# NEWPARK

RE: UDPRP Advice for One Newpark, Presented to the Panel on October 23, 2020

[EXHIBIT A]

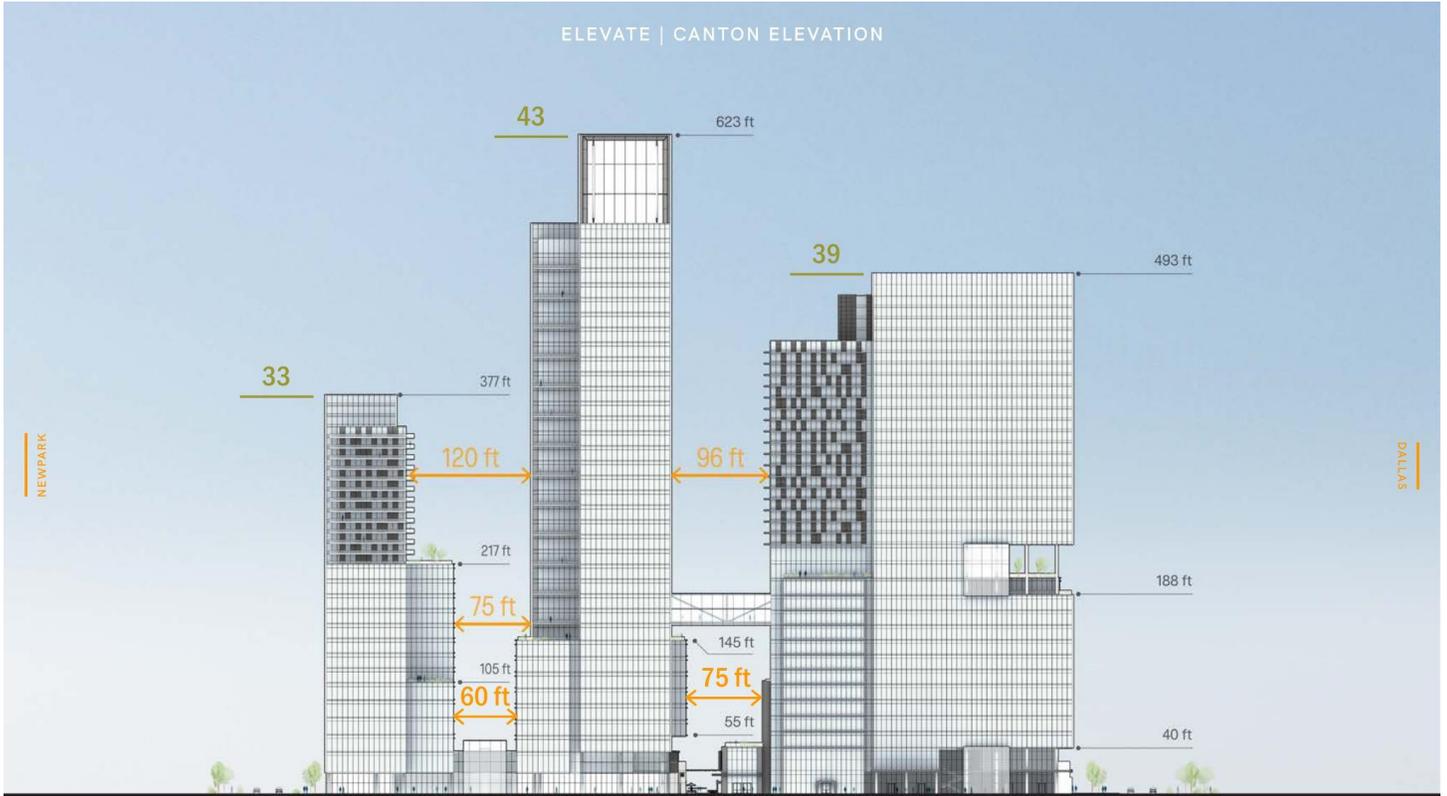
- [5] The Panel recommends the design team consider softening the façade along Canton Street to help balance the monumentalism that exists at and around Dallas City Hall.

Response: Due to the cores of the multiple mix of uses and structural grids necessary to support all the uses stacked vertically in the building, it will be financially unfeasible to make significant changes to the façade along Canton Street. Please see Exhibit A that illustrates how the façade along Canton Street has been designed further to develop the building in a manner that is appropriate for a downtown high-rise in the setting which is appropriate for significant density and urban form.

[EXHIBIT B]

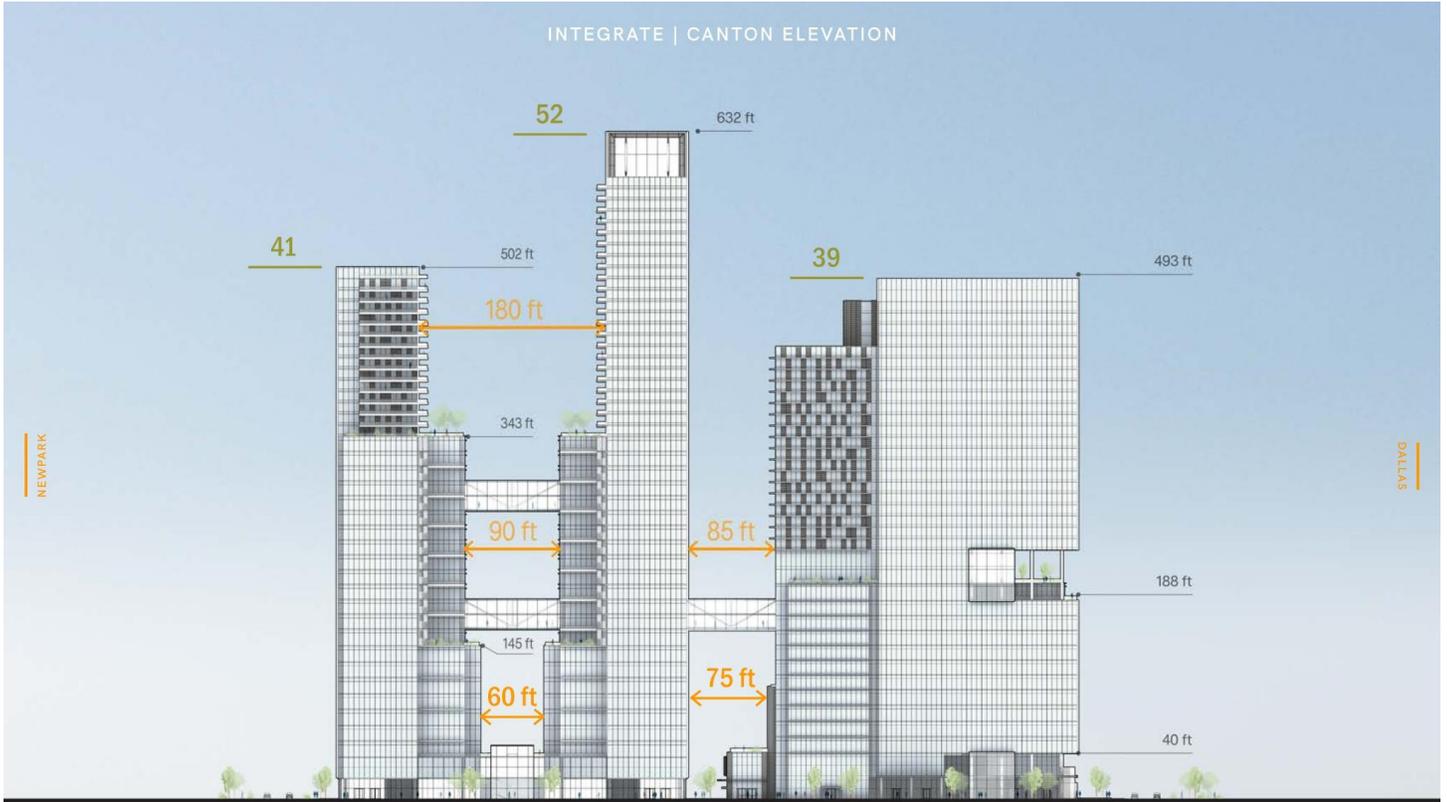
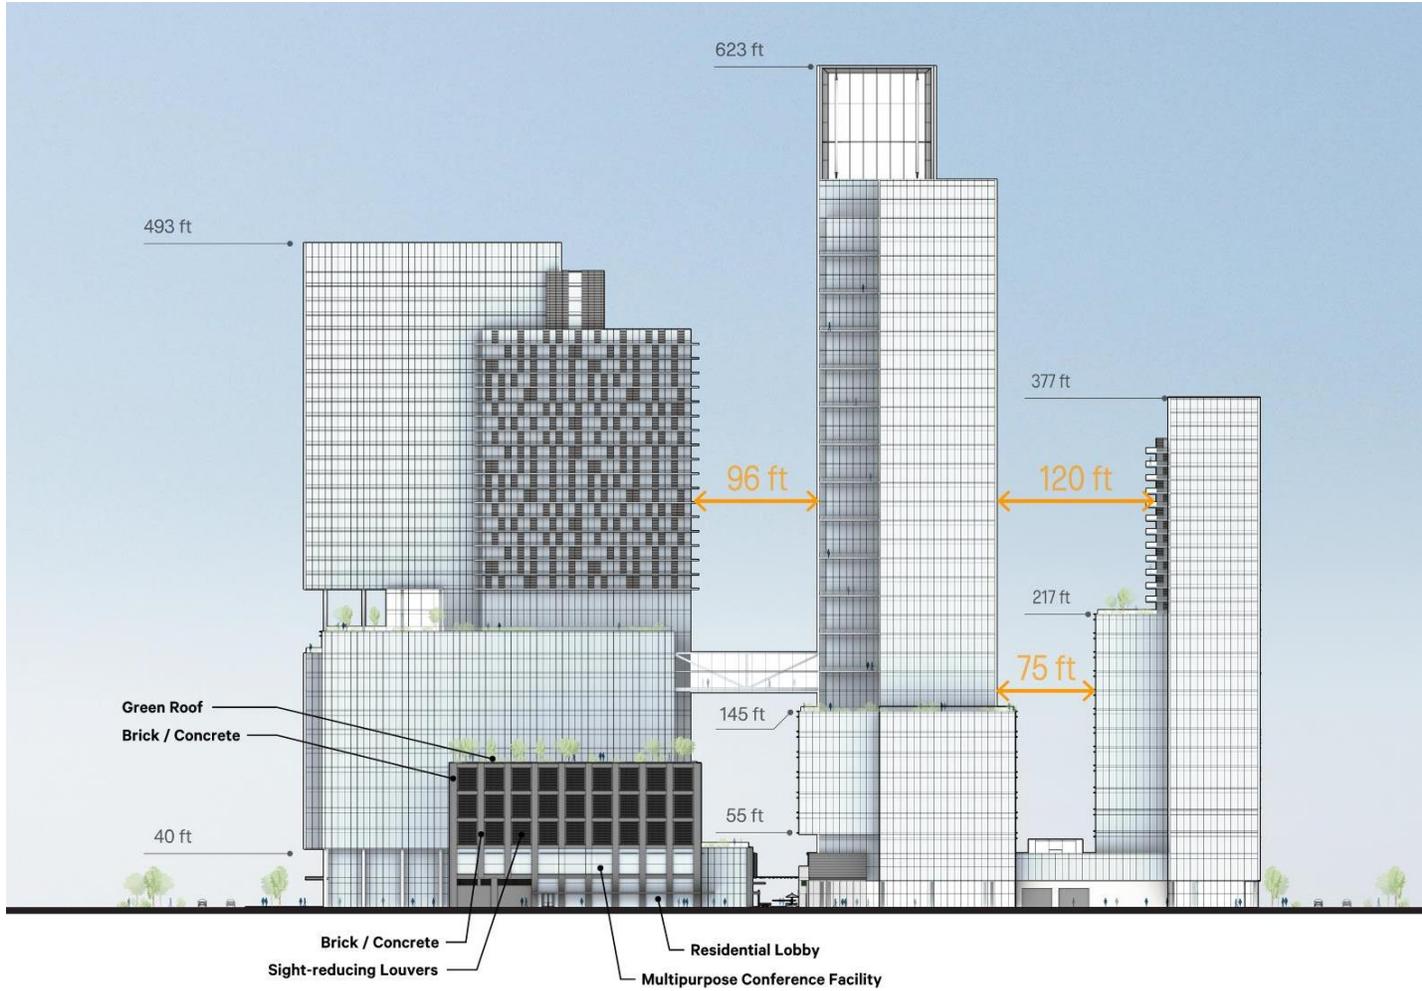
- [6] The Panel advises that the overall master plan work with this phase and future phases and their massing to mitigate the feeling of a wall, including thought being given to the design of future pedestrian mews between Canton and Cadiz to break down this barrier.

Response: Please see Exhibit B illustrating refinements to the overall master plan in order to address concerns of the massing feeling like a wall.

[EXHIBIT C]

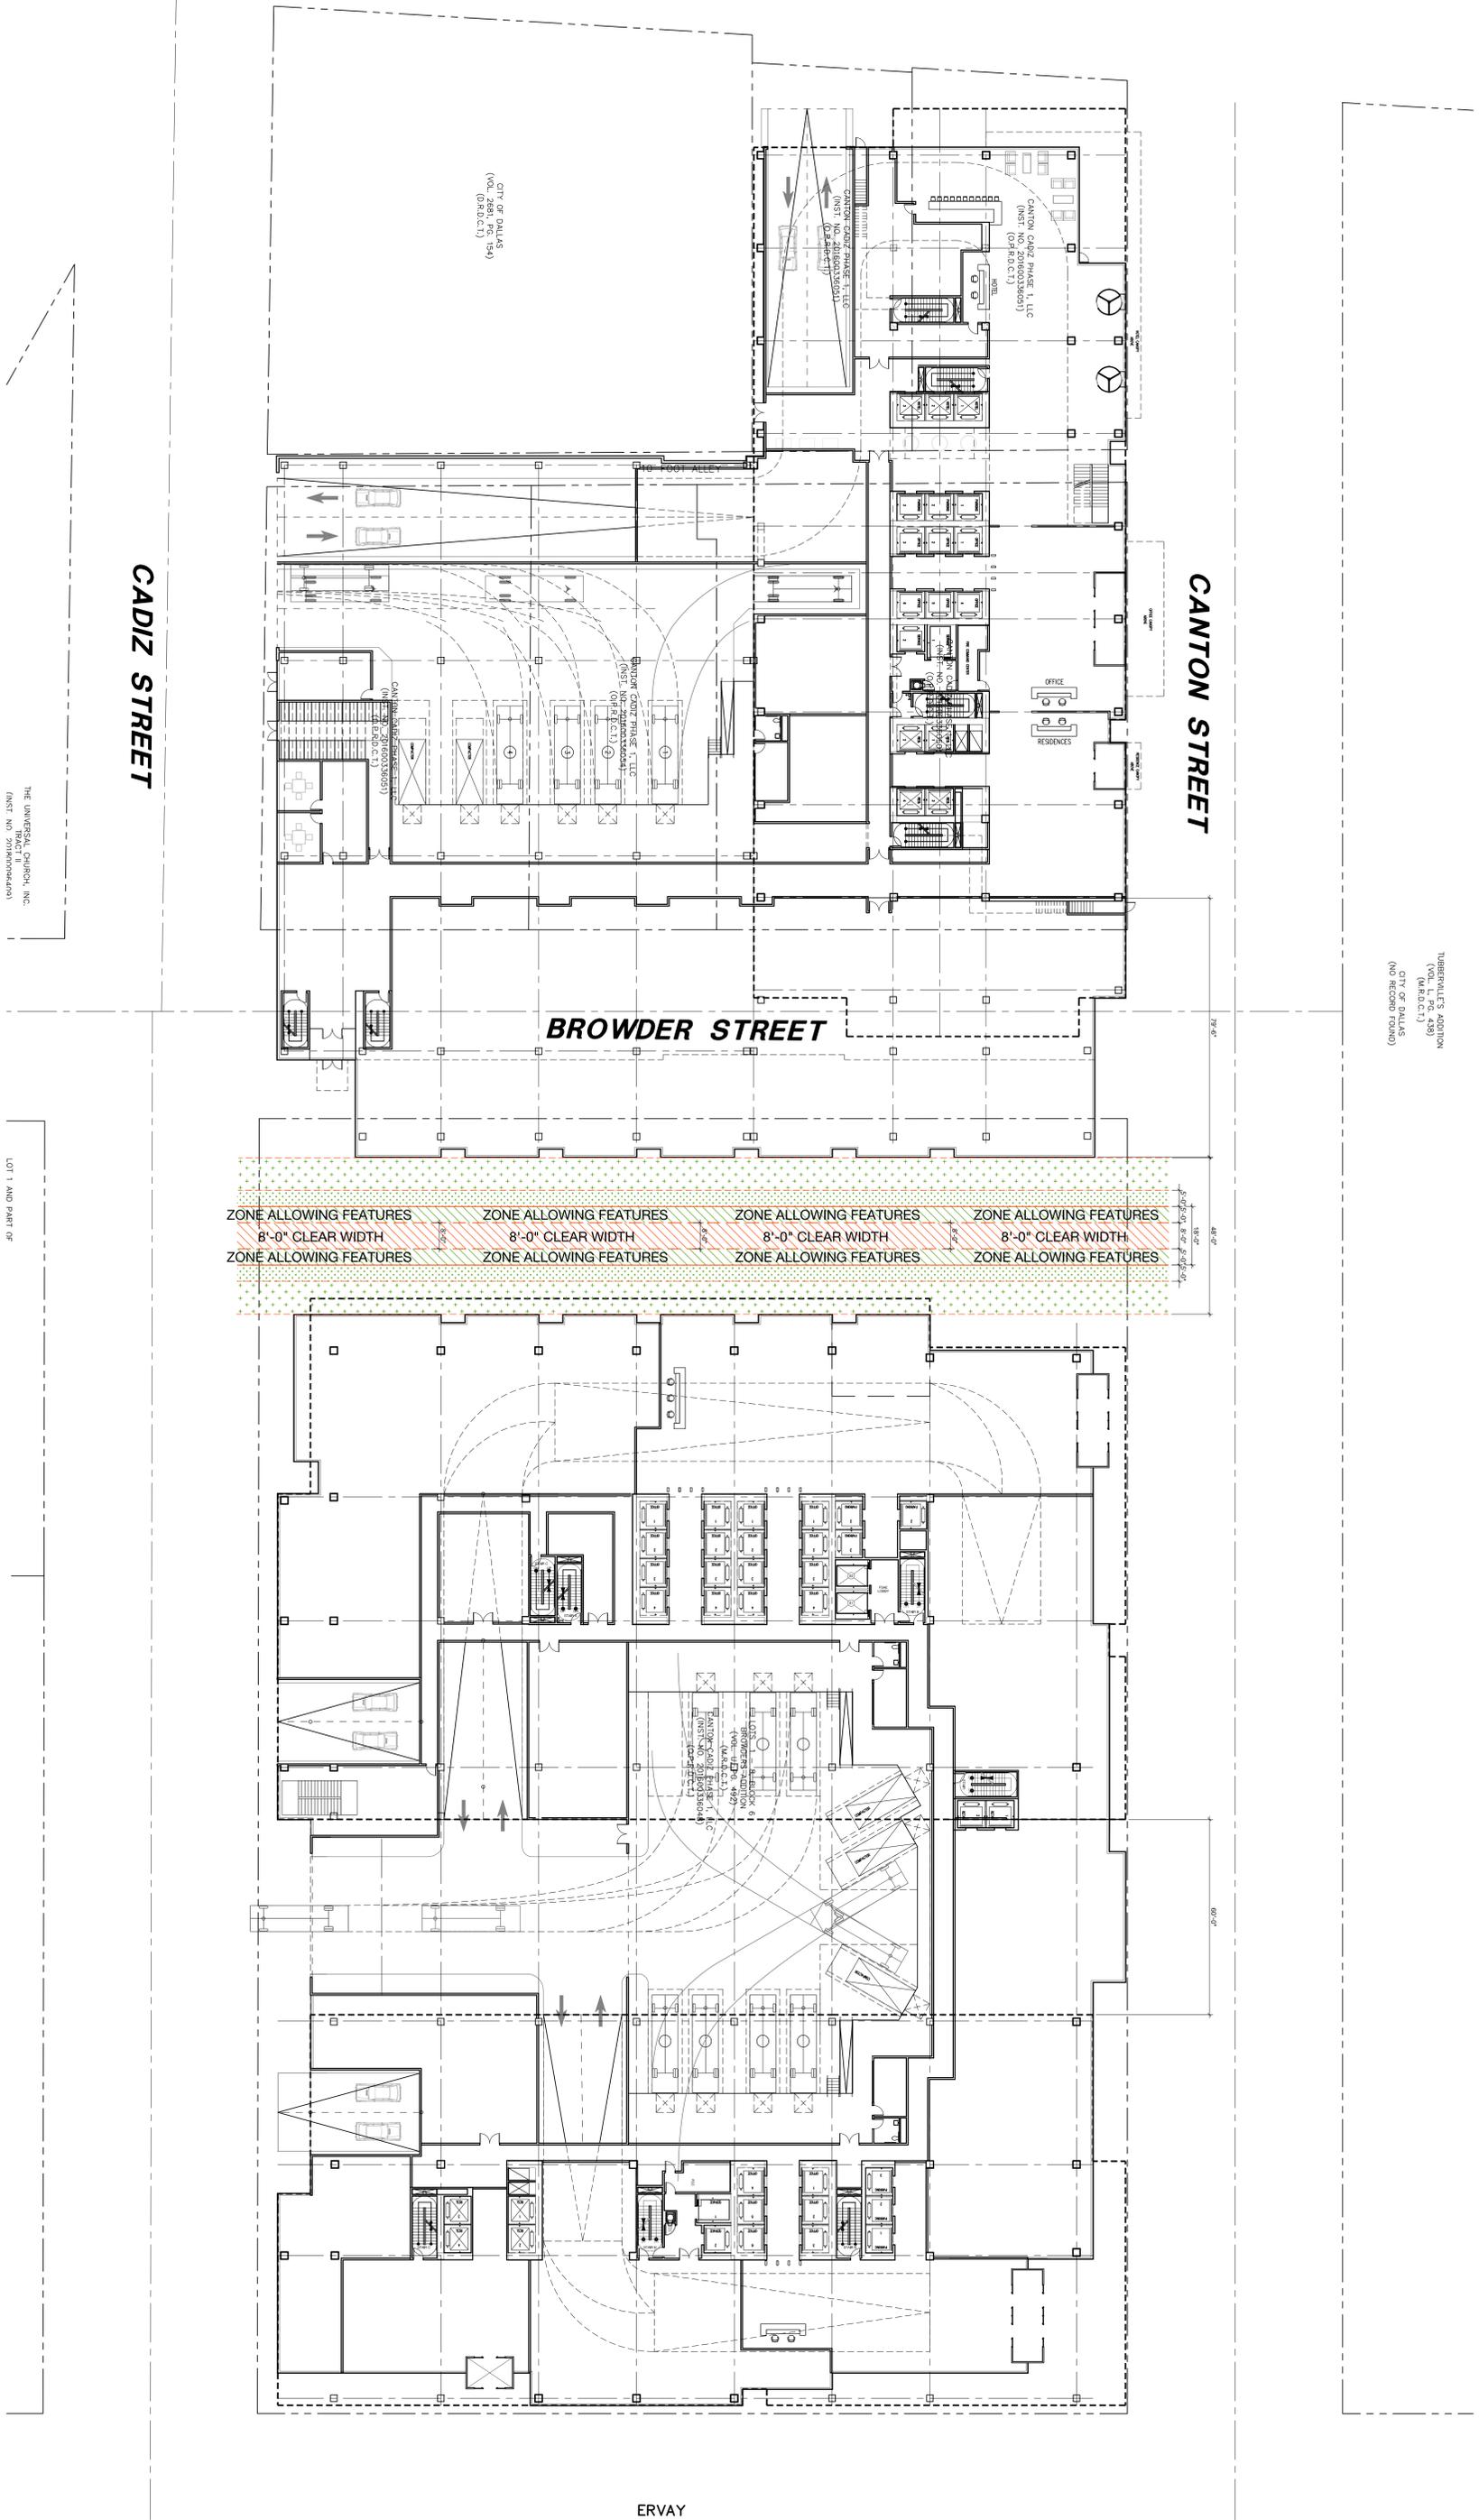
- [8] The Panel expresses concern about the design of the facades of the parking structure, especially on the rear-side of the building facing the fire station property.

Response: Please see Exhibit C illustrating the design intent for the building materials on the garage and how the facades of the parking structure are activated on all sides. All sides of the parking garage will be skinned with building materials to ensure all sides of the building are activated.

[EXHIBIT D]

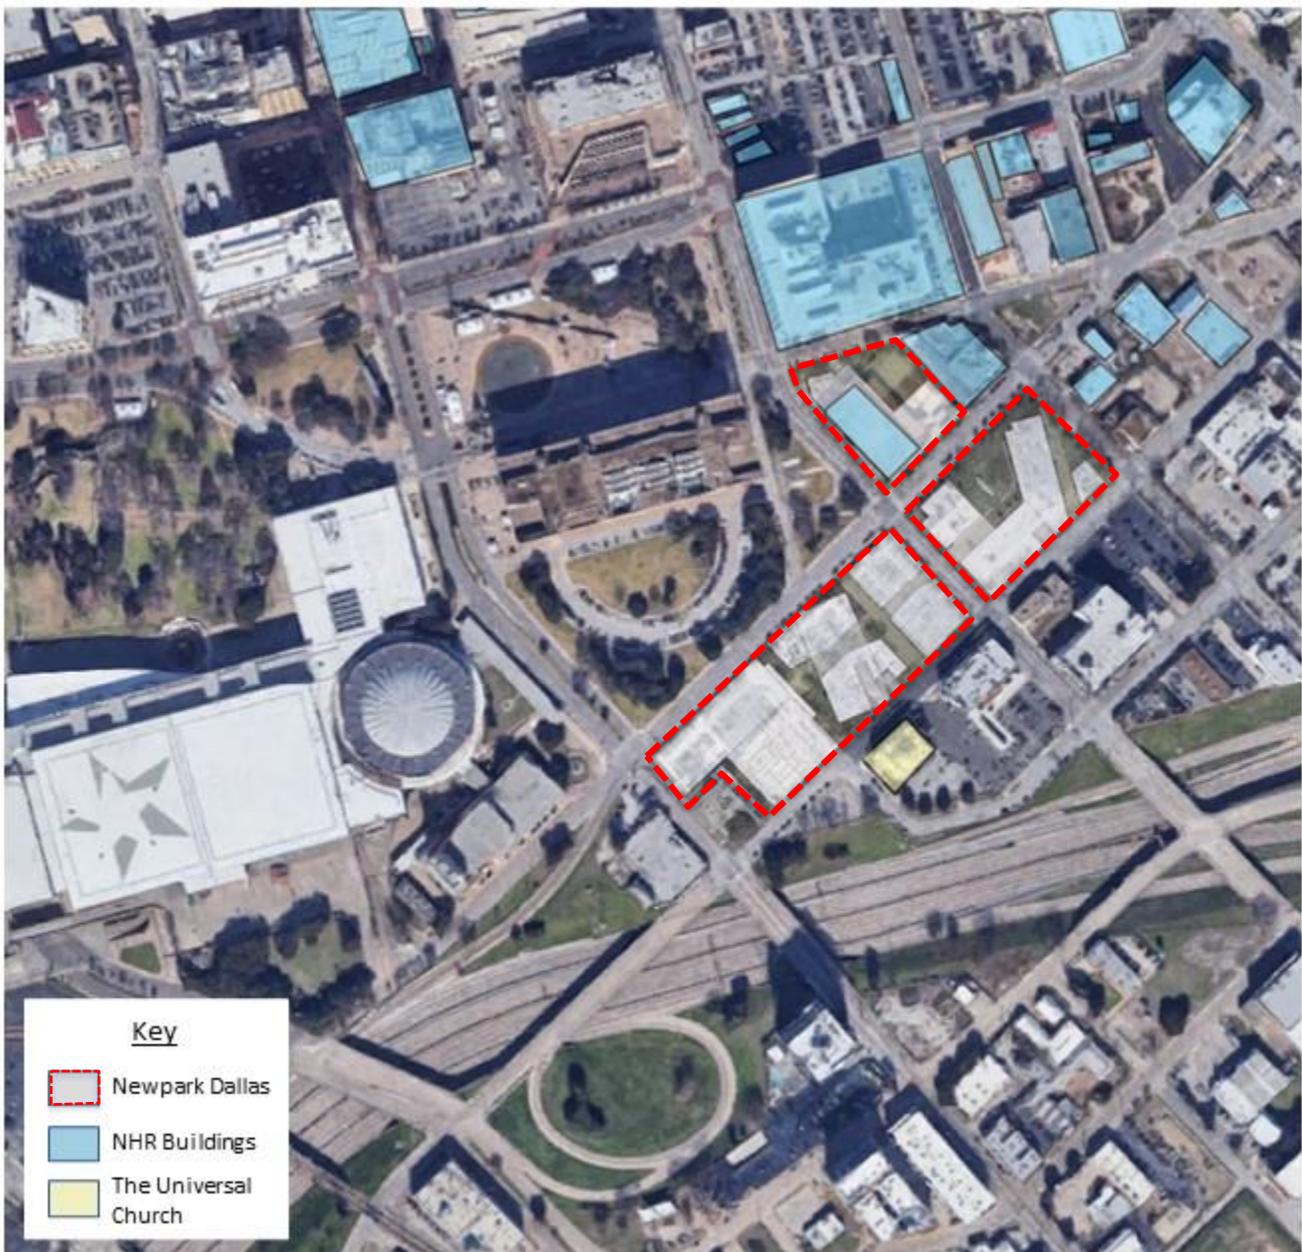
*Response: We have met with City departments regarding proposed street changes and bike infrastructure improvements, and we will continue to work hand-in-hand with them.*  
*City Response (3.10.21): Per the abandonment request of Browder, please provide a plan diagram of the proposed pedestrian mews replacing Browder Street, indicating dimensions of the space and the sidewalk.*

Newpark Response: Please see Exhibit D attached.
